WARRANTY BULLETIN

Wb10-30

DATE : JULY 2010	SECTION :	12 - Brakes
EXPIRATION: JULY 2012		
SUBJECT : RELOCATING ABS AND ATC CABLE IN REAR WHEELHOUSING

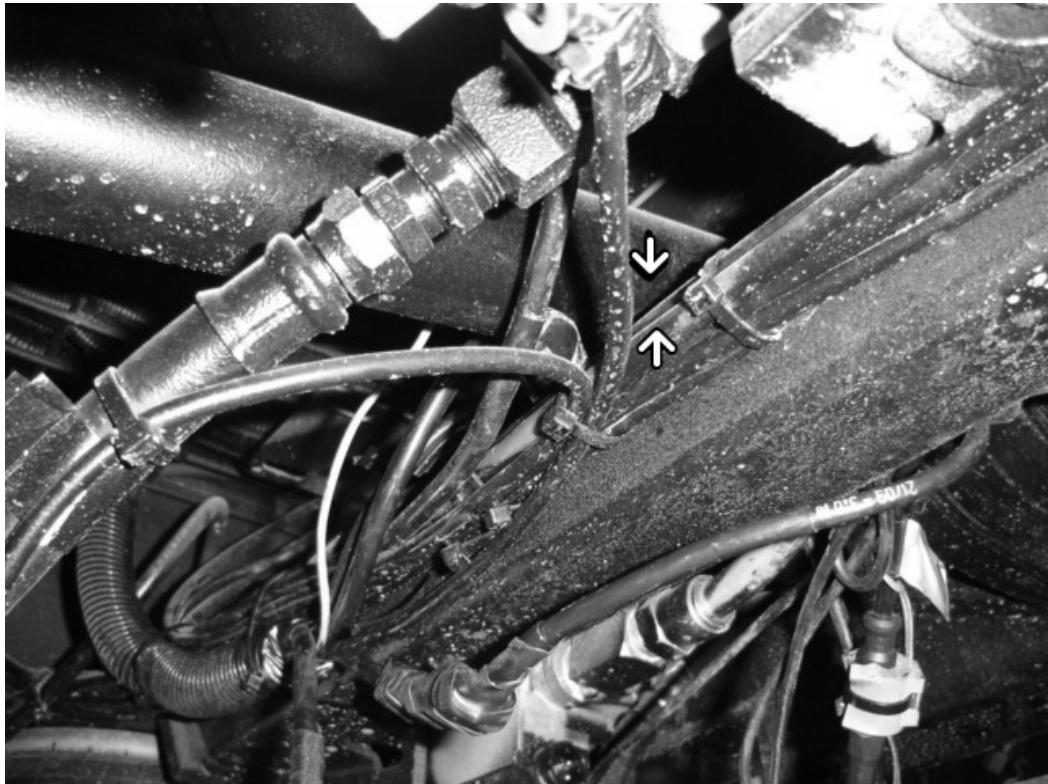
On the vehicles affected by this bulletin, there is a possibility that the ABS and ATC cable be damaged due to its location on the structure horizontal cross member. Pinching or cutting the ABS and ATC cable may cause system malfunction or the telltale light to come on.

This condition may occur when the drive axle is raised and the tag axle is lowered to the maximum, the upper tag axle longitudinal radius rod can then lean against the structural cross member and damage the cable.

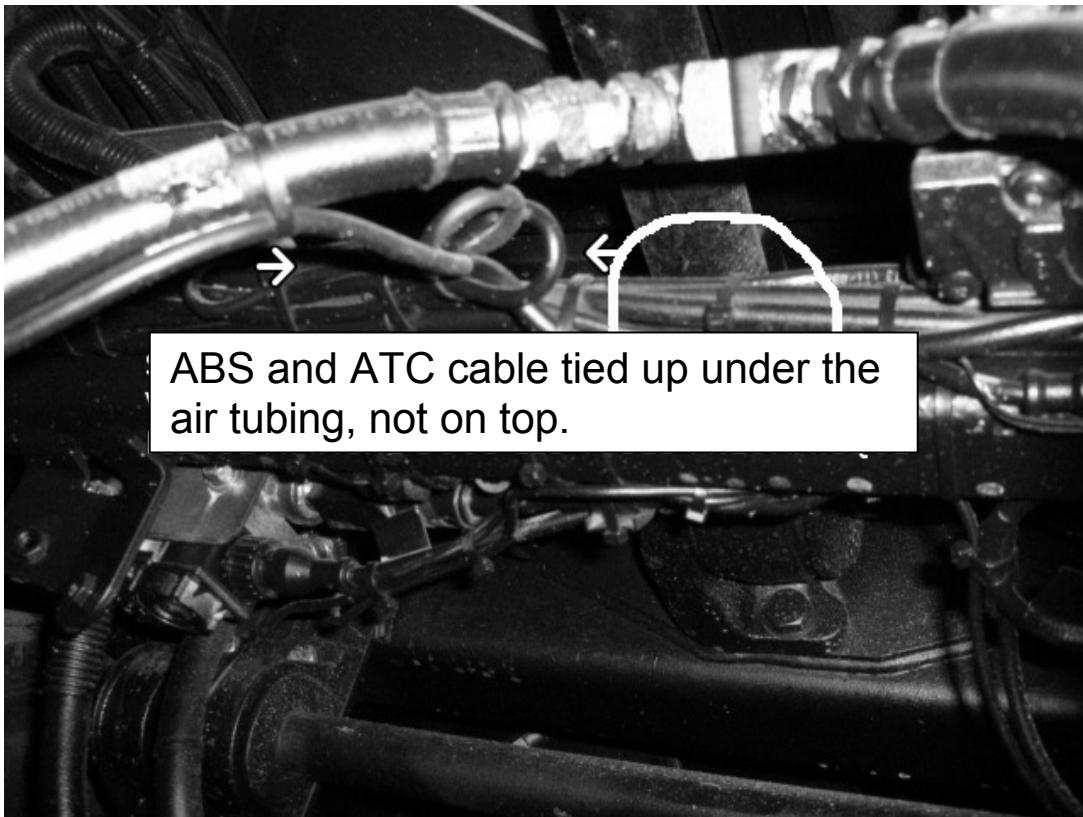
1. In the rear wheelhousing, locate the ABS and ATC cable on the structure horizontal cross member.

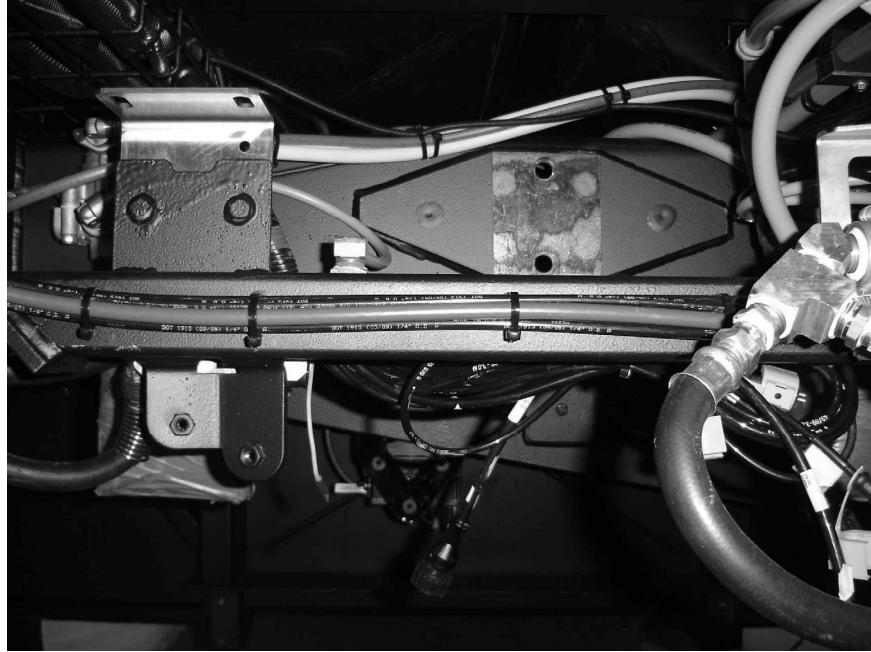
2. To prevent the ABS and ATC cable from coming in contact with the longitudinal radius rod, check that it is tied up under the air tubing and not on top.

3. Position that ABS and ATC cable under the air tubing if necessary.

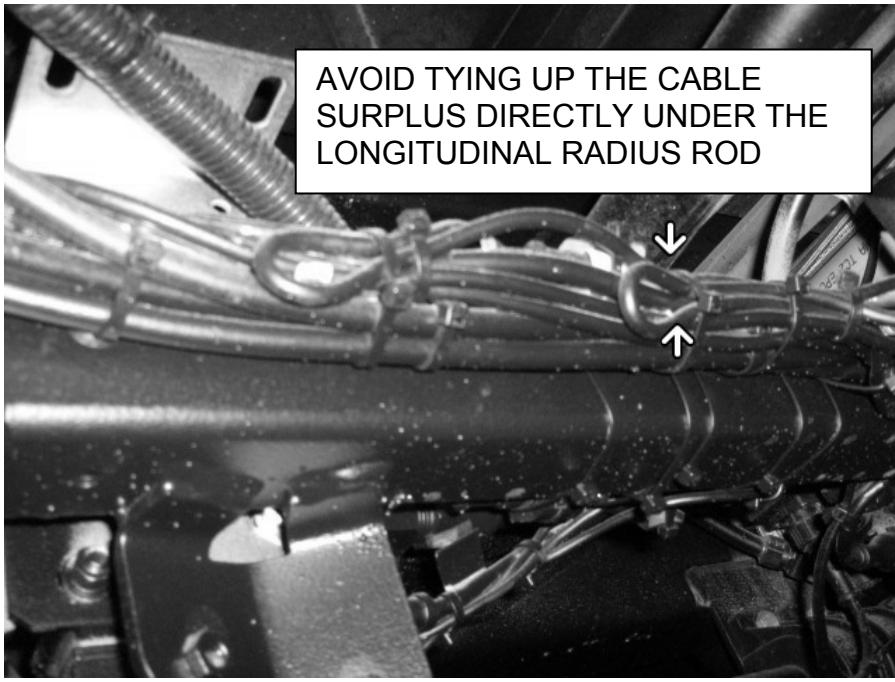
Avoid tying up the cable surplus directly under the longitudinal radius rod.
